CITY OF WICHITA

November 21, 2012

BZA2012-60: City request for an Administrative Adjustment to reduce parking by 25% based on remodeling/expansion of a restaurant; generally located south of Wassel Street, east of Hydraulic Avenue on the north side of Northern Street (1714 E Northern Street)

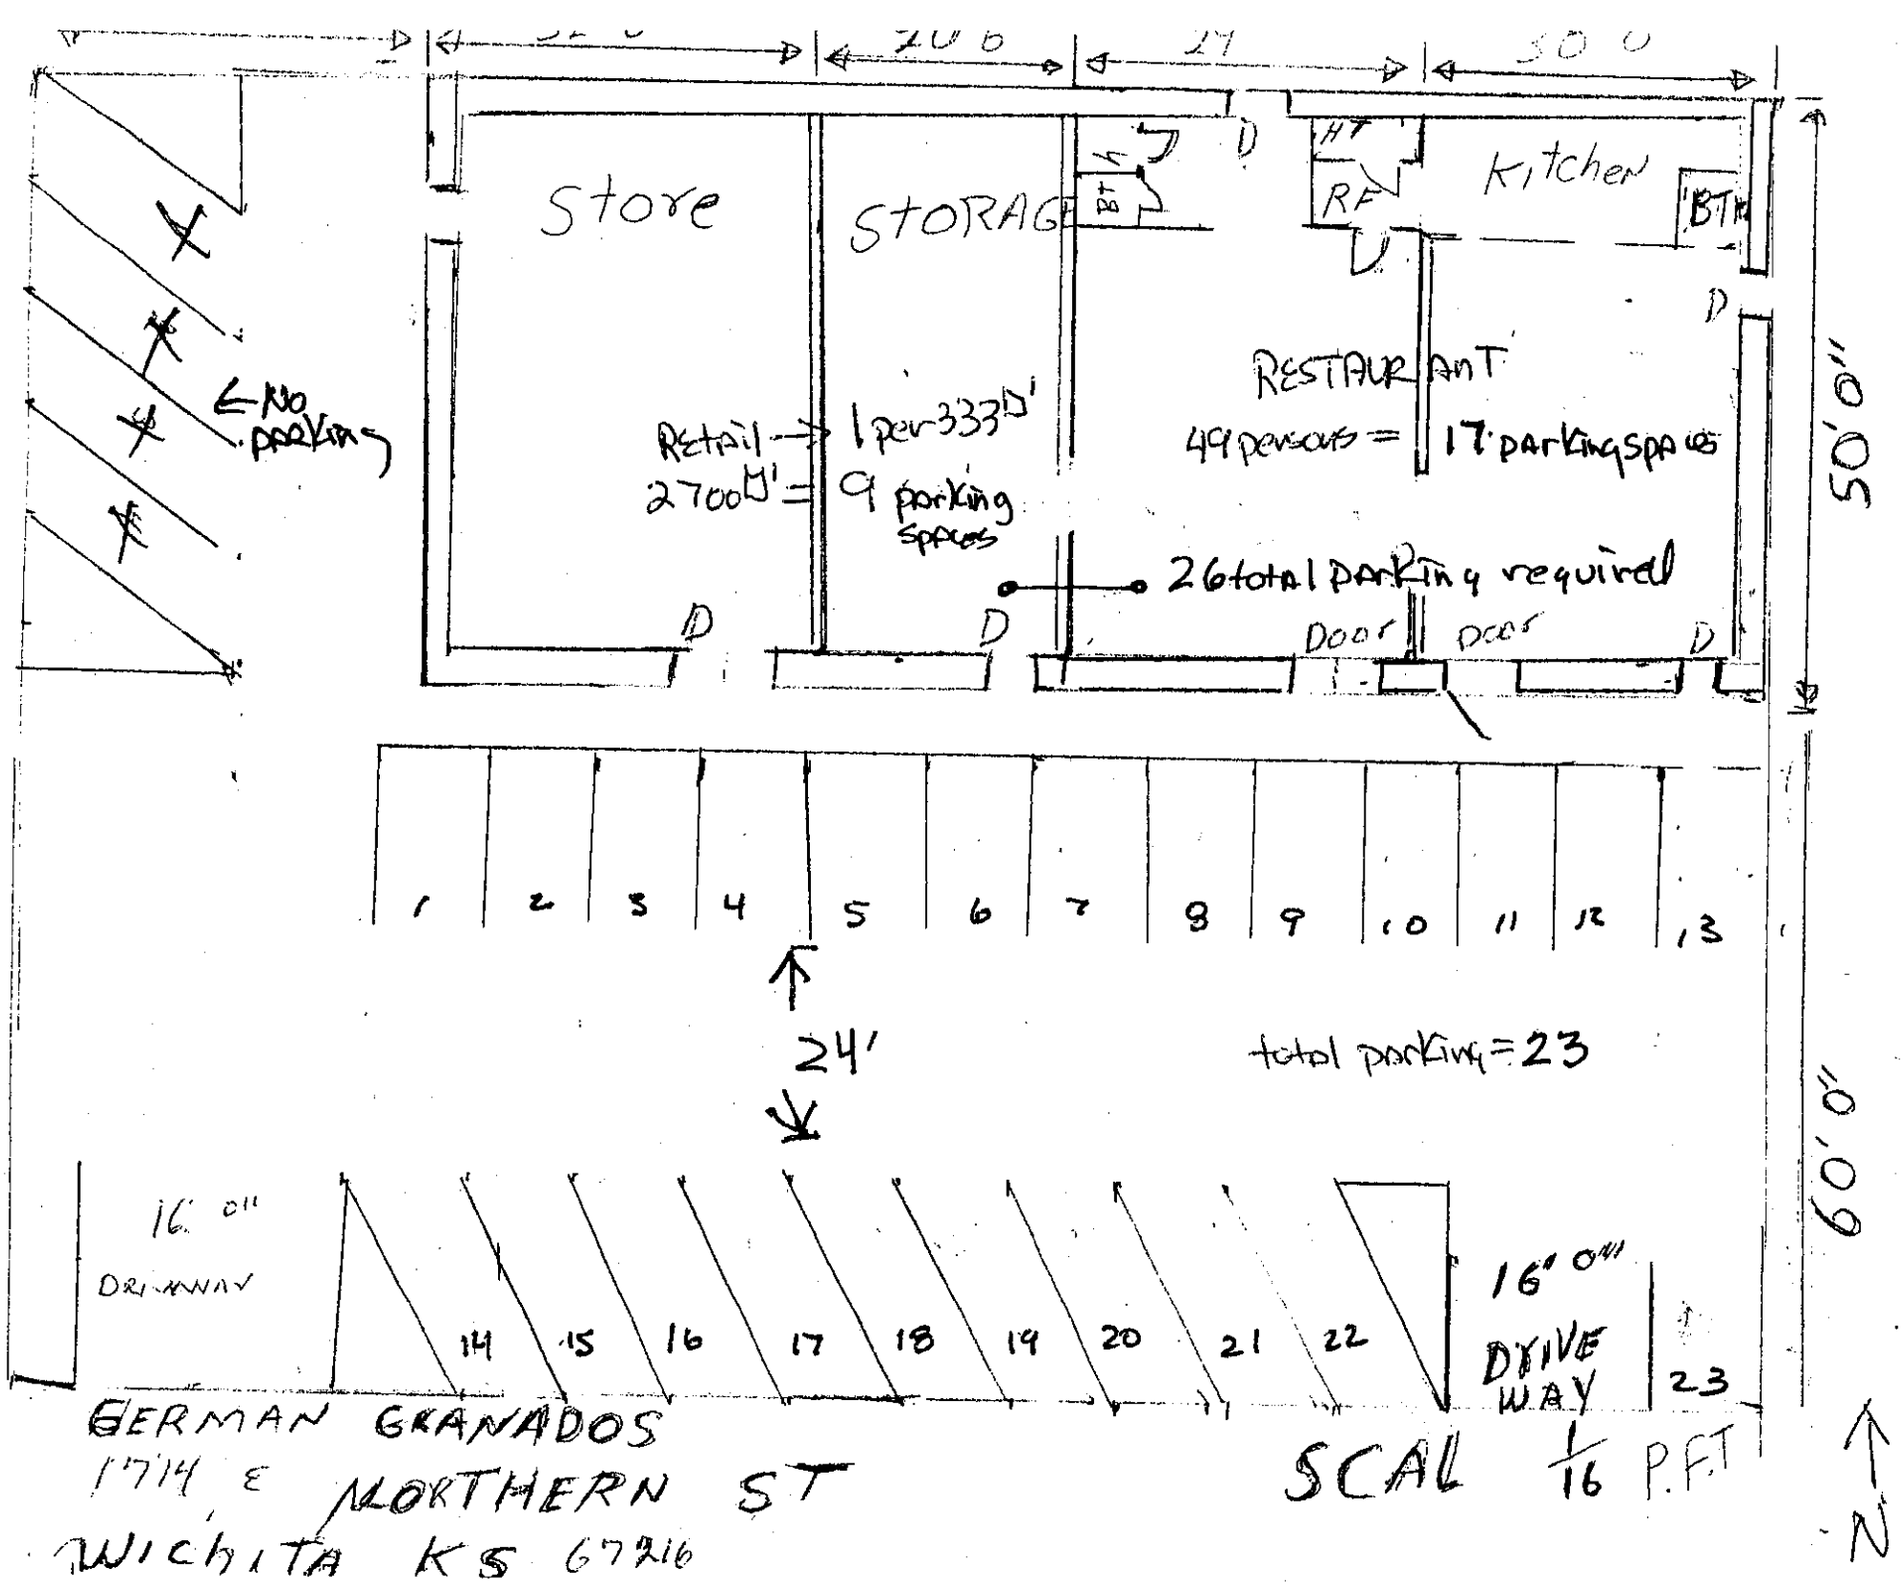
We have reviewed your Zoning Adjustment request to reduce the parking requirement on the above-referenced property. From reviewing your application we understand that you are remodeling and expanding on an existing building on the property. Your site plan shows 23 parking spaces for the remodeled restaurant and retail. The Unified Zoning Code (UZC) requires a total of 26 parking spaces for the combination of a 49 seat capacity restaurant (per Fire) and 2,700-square feet of remodeled retail: one parking space per 3 seats for a restaurant and 1 parking space for 333 square feet of retail.

Sec. V-I.2.i of the Unified Zoning Code allows an adjustment to reduce the parking requirement by 25% when the conditions required by Sec. V-I.6 of the Code are met. We find that the reduction of the parking requirement as proposed meets the four conditions required by Sec. V-I.6 of the Code as set out below:

1) Impact on safety and convenience of vehicular and pedestrian circulation: The proposed reduction in parking requirement should have no impact on the safety and convenience of vehicular and pedestrian circulation in the vicinity of the application area. Sufficient parking should be available for the anticipated need, and the parking does not interfere with public right-of-way.

2) Impact on existing uses in surrounding areas: The proposed reduction in parking should not impact existing uses in surrounding areas, as all parking for this project should be adequately provided on the site.

3) Compatibility with existing or permitted uses on abutting sites: A 25% parking reduction should not compromise existing or permitted uses on abutting sites, as all parking for this project should be adequately provided on the site.

4) Effect on public health, safety or welfare: There will be no encroachment into public right of way or utility easements; the public's safety, health and welfare should not be impacted.

Our signatures below indicate that an administrative adjustment to reduce parking by 25%, from 26 spaces to 20 spaces is hereby granted for the aforementioned property subject to the following conditions:

1) The site shall be developed in general conformance with the approved site plan.
2) All parking on the site shall be paved and marked in accordance with City standards.
3) If the Zoning Administrator finds that there is a violation of any of the conditions of the Zoning Adjustment, the Zoning Administrator, in addition to enforcing the other remedies set forth in the Unified Zoning Code, may, with the concurrence of the Planning Director, declare that the Zoning Adjustment is null and void.
